MERIDIAN SERVICE METROPOLITAN DISTRICT WATER TREATMENT PLANT EXPANSION

PCD File No. PPR-22-012

MERIDIAN SERVICE METROPOLITAN DISTRICT
WATER TREATMENT PLANT EXPANSION
GRADING AND EROSION CONTROL PLAN

C7

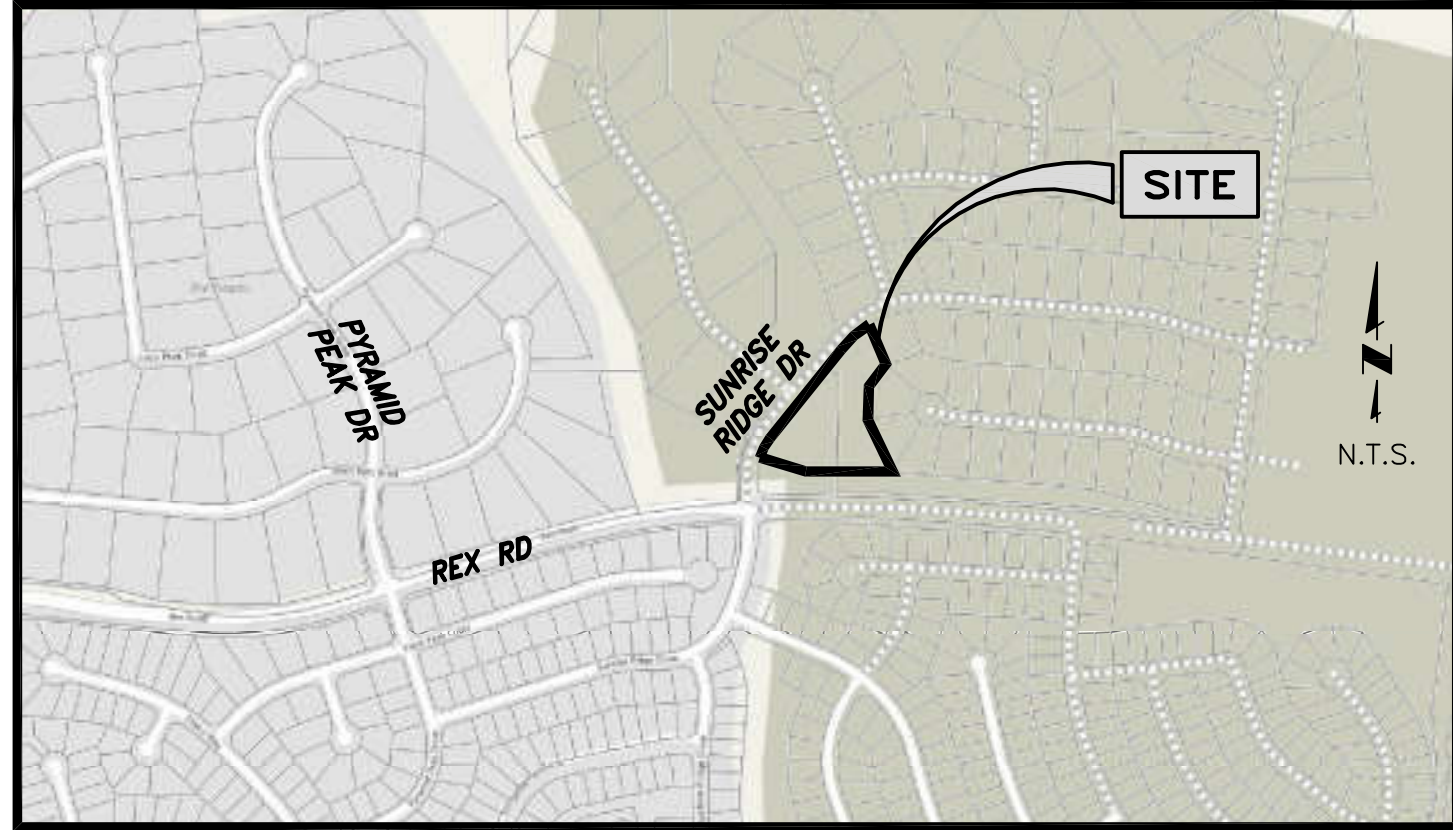
Show Limits of disturbance

GEC Checklist Item bb. call out RPA and put swales in a drainage easement.

TSB (Initial) should be installed prior to discharge from the Site. TSBs are temporary and provide WQ during construction before the swales and all other disturbance is established and vegetated. They are required for all sites with >1ac disturbance.

Provide details of temporary sediment basin including riser pipe diameter and perforation sizing, number of rows of holes, required volume, location of outlet pipe and spillway, and tributary area to the sediment basin. And provide contours for sediment basin.
